ADDENDUM NO. 1
TO CONTRACT DOCUMENTS FOR THE
ANDERSON DAM TUNNEL PROJECT
Project No. 91864005 Contract No. C0663

Notice is hereby given to Prospective Bidder that the Contract Documents are modified as hereinafter set forth.

19. **REPLACE** the following Sheet Codes as shown in ATTACHMENT NO. 2

SCALE	PROJECT NUMBER
AS NOTED	91864005
VERIFY SCALES	SHEET CODE: 1
0 1" BAR IS ONE INCH ON ORIGINAL DRAWING IF NOT ONE INCH ON THIS SHEET, ADJUST SCALES ACCORDINGLY	C-031
	SHEET NUMBER: 39 OF 146

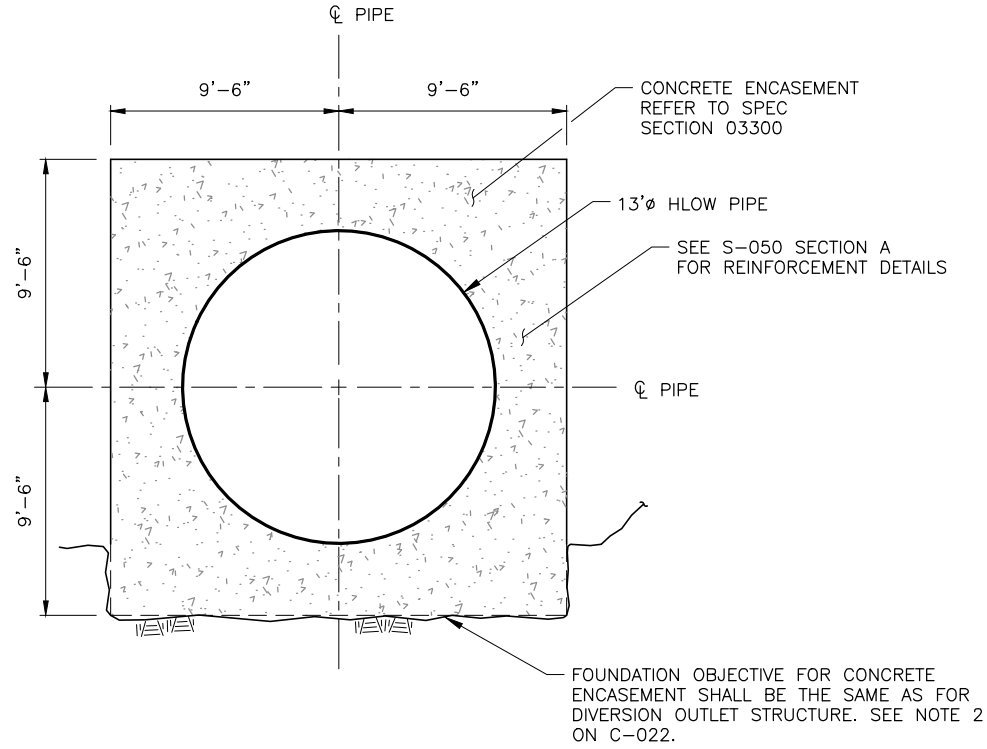
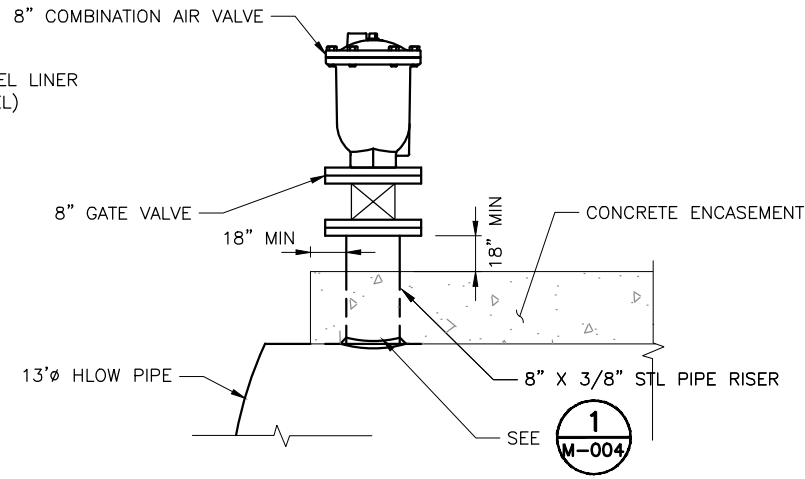
REV	DESCRIPTION	DATE	APPR.	REFERENCE INFORMATION AND NOTES
1	1. REFERENCED PIPE SCHEDULE (ADD #1)	02/21	JWR	
ADDENDA DRAWING 02-15-2021 CEII - DO NOT RELEASE

SCALE 1"=50'	PROJECT NUMBER 91864005
VERIFY SCALES 	SHEET CODE: C-300
	SHEET NUMBER: 60 OF 146

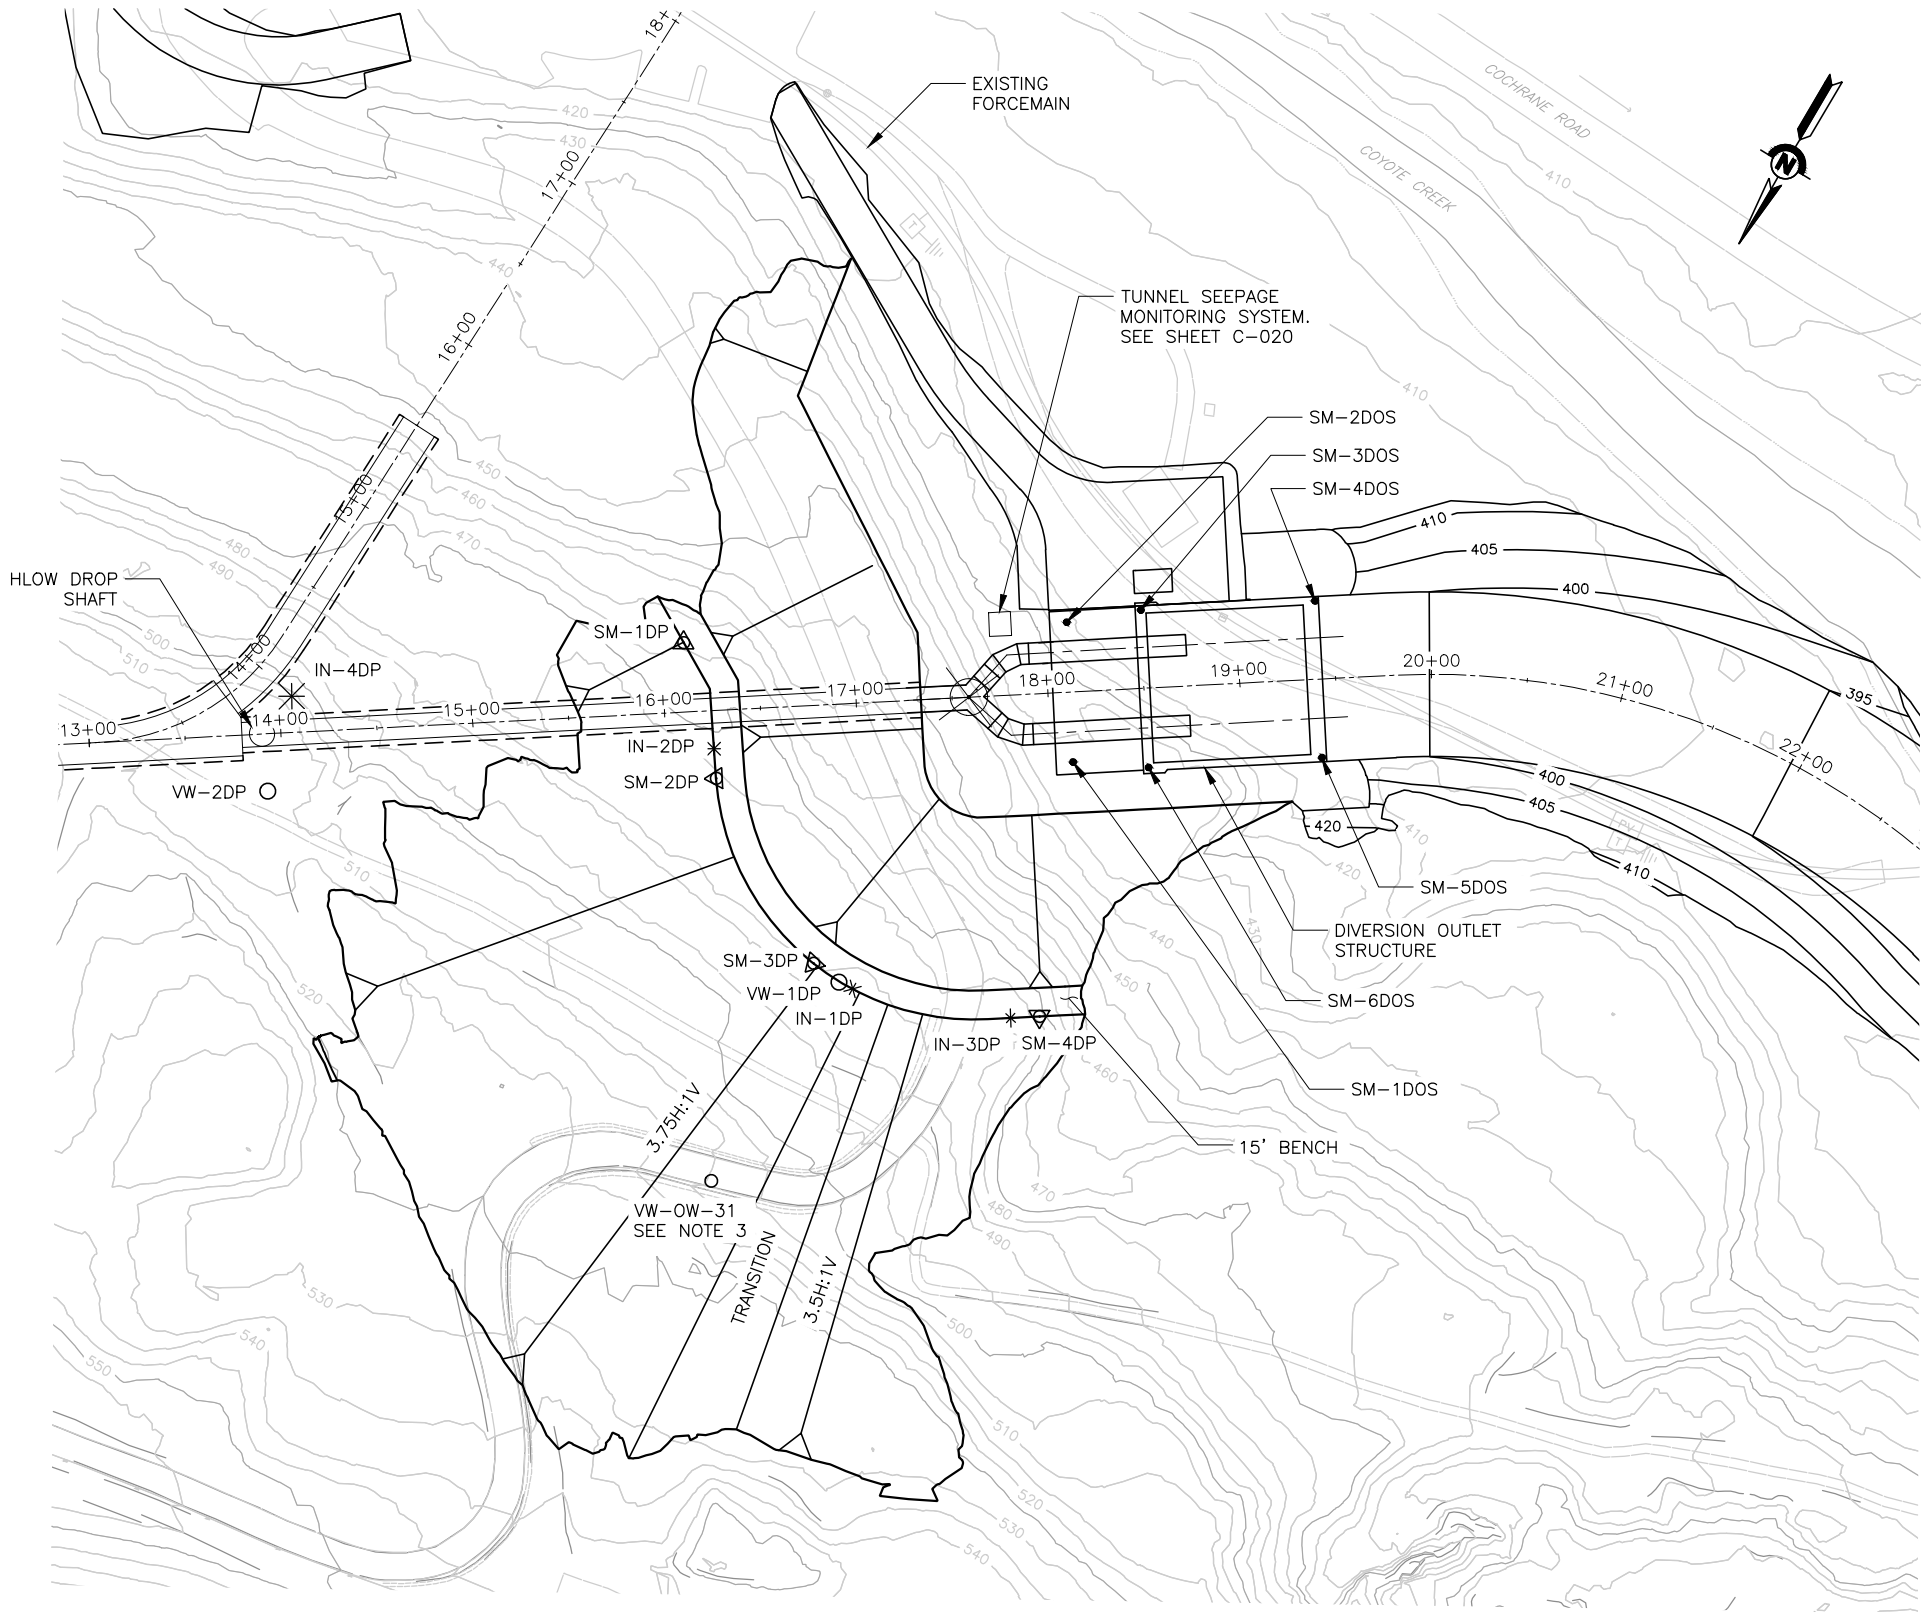
REV	DESCRIPTION	DATE	APPR.	REFERENCE INFORMATION AND NOTES
1	1. IN-4DP TIP ELEVATION REVISED (ADD. #1)	02/21	JWR	
ADDENDA DRAWING 02-15-2021 CEII - DO NOT RELEASE

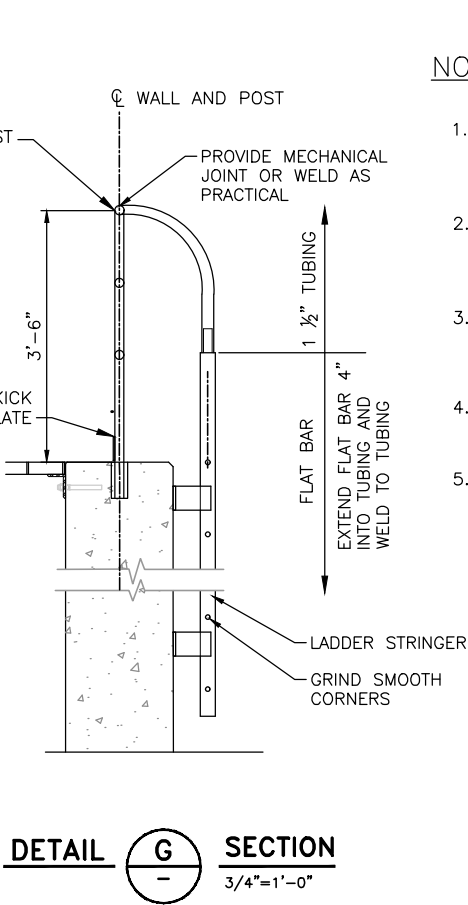
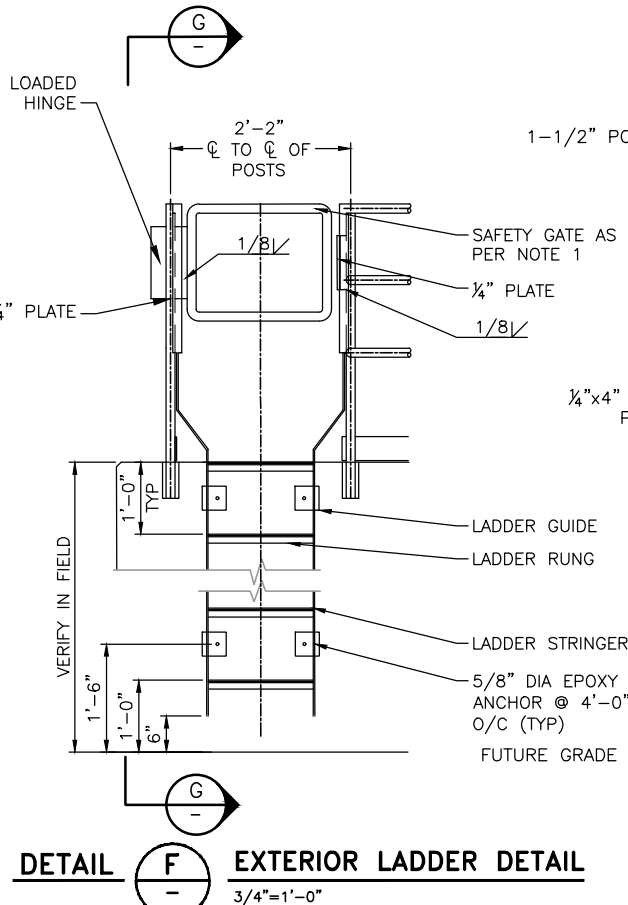
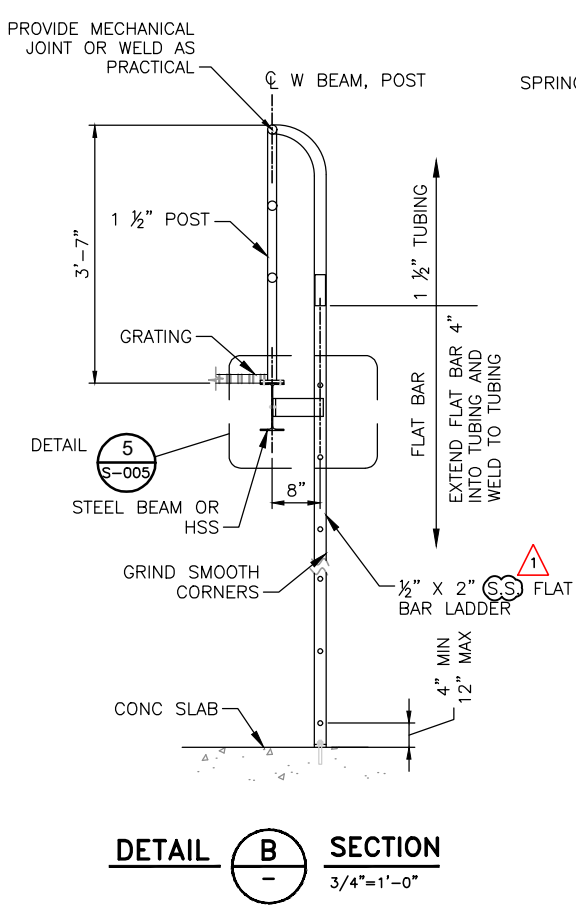
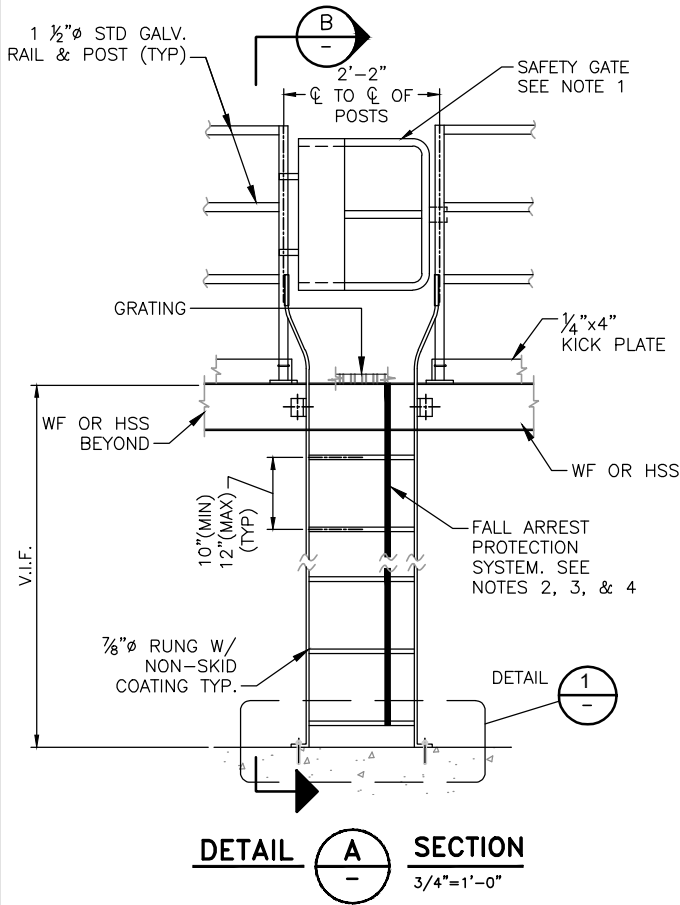
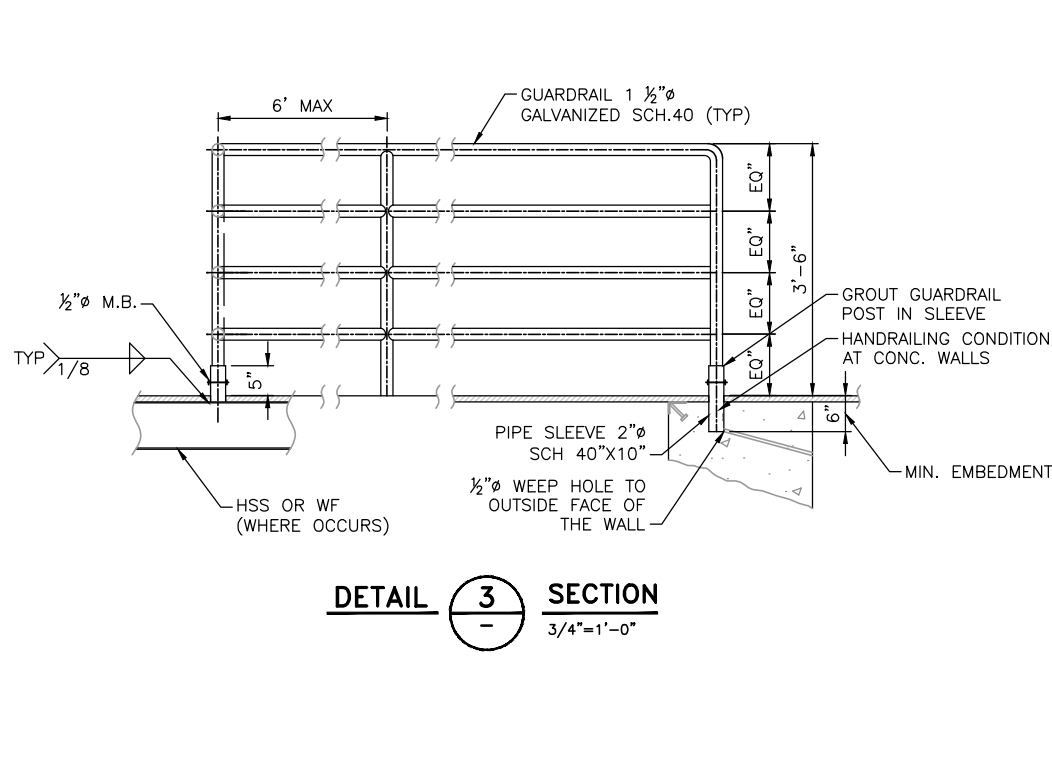
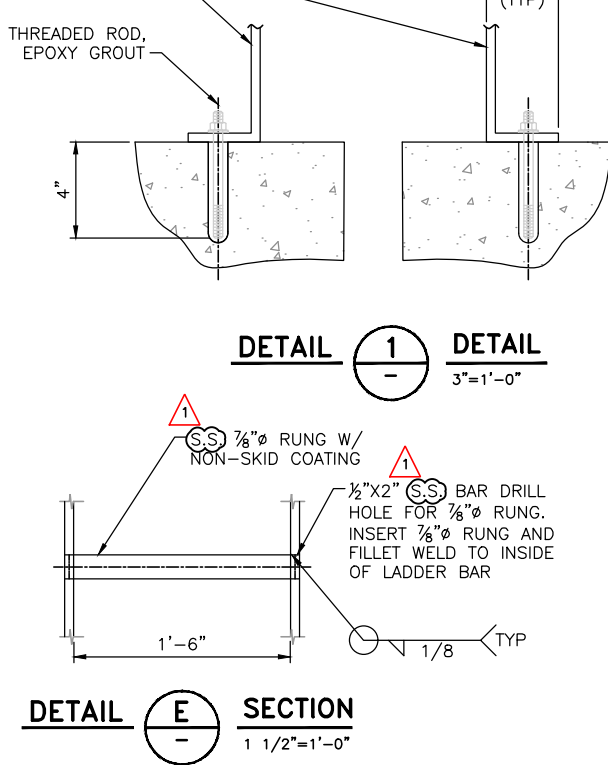
Specification 05500, Section 2.03.A.1 says that ladders are to be fabricated of stainless steel plates, bars and angles. Details C, D, and E on Drawing S-004 call for galvanized materials. Specification 05500, Section 2.03.D.7.c calls for galvanized steel framing on fabricated stairs if not stainless. Please clarify the material type and finish for the stairs, ladders, and platforms at the Diversion Outlet Structure.

Note 5 on S-004 states that, unless shown otherwise on the drawings, provide a 4 rail system as shown on Detail 3 for outdoor applications and a 3 rail system with kickplate as shown on Section a for indoor applications. Drawing S-026 shows a 3 rail system for the stairs and platform, but no kickplate. Are kickplates required at this location?

The material type and finish for the ladders is stainless steel, the material type and finish for the stairs and platforms at the Diversion Outlet Structure is hot-dip galvanized (HDG). S-004 and S-005 have been revised. See item nos. 19(d) and 19(e), and Attachment No. 2 of Addendum No. 1.

The kickplates are required on the platforms, but not required for the stringer.
